COUNCIL ASSESSMENT REPORT

SYDNEY EASTERN CITY PLANNING PANEL

Panel Reference	PPSEC-245
DA Number	DA-2022/357
LGA	Bayside Council
Proposed Development	Integrated Development - Demolition of existing structures and construction an 8 storey self-storage facility and 12 storey commercial building with above ground parking and landscaping
Street Address	1-3 and 3A Ricketty Street, Mascot
Applicant/Owner	<u>Applicant</u> : The Trustee for the Canal Aviv Trust <u>Owner</u> : Canal Aviv Pty Limited
Date of DA lodgment	1 December 2022
Number of Submissions	2 (in the first round)
Recommendation	Refusal
Regional Development Criteria (Schedule 7 of the SEPP (State and Regional Development) 2011	Private infrastructure and community facilities over \$30 million (Nominated CIV: \$49,786,000)
List of all relevant s4.15(1)(a) matters	<ul style="list-style-type: none"> • State Environmental Planning Policy (Planning Systems) 2021 • State Environmental Planning Policy (Biodiversity and Conservation) 2021 • State Environmental Planning Policy (Industry and Employment) 2021 • State Environmental Planning Policy (Resilience and Hazards) 2021 • State Environmental Planning Policy (Transport and Infrast

Figure 5: Stage 1 plan showing bicycle path works being completed wholly within the Stage 1

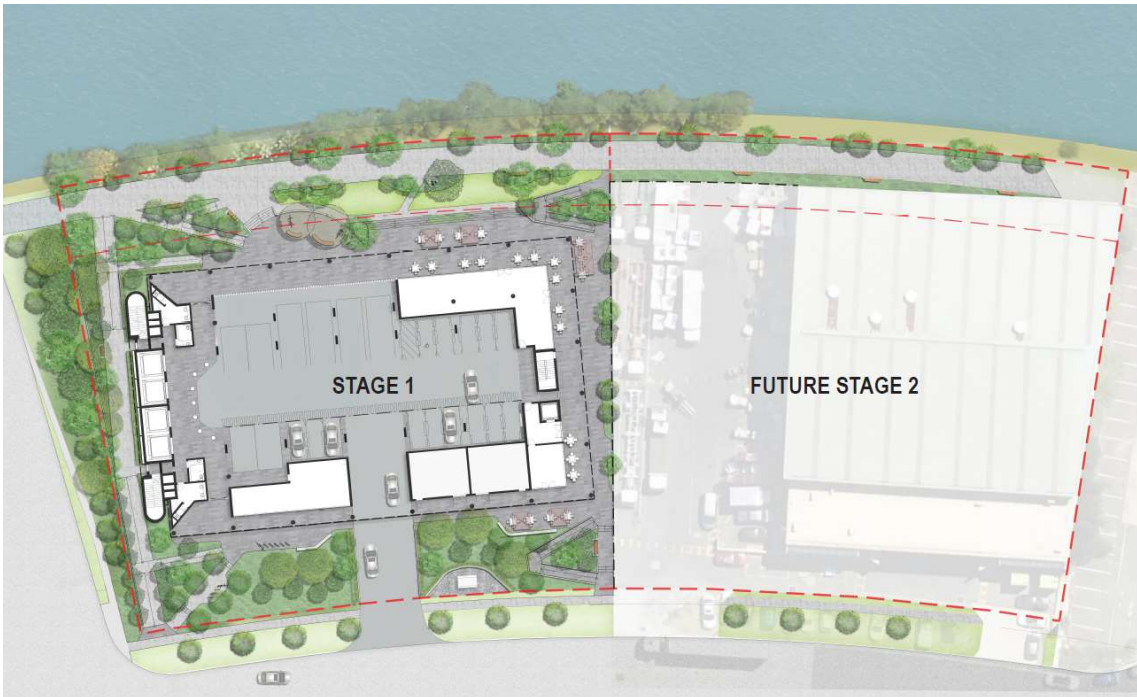
- Staging of Development – The existing industrial building within the area containing stage 2 is subject to a long term lease and hence the office building can only be constructed at a later date. This has resulted in the need for staged development of the site. The plans have been amended to ensure that the bicycle path would all be constructed within Stage 1.
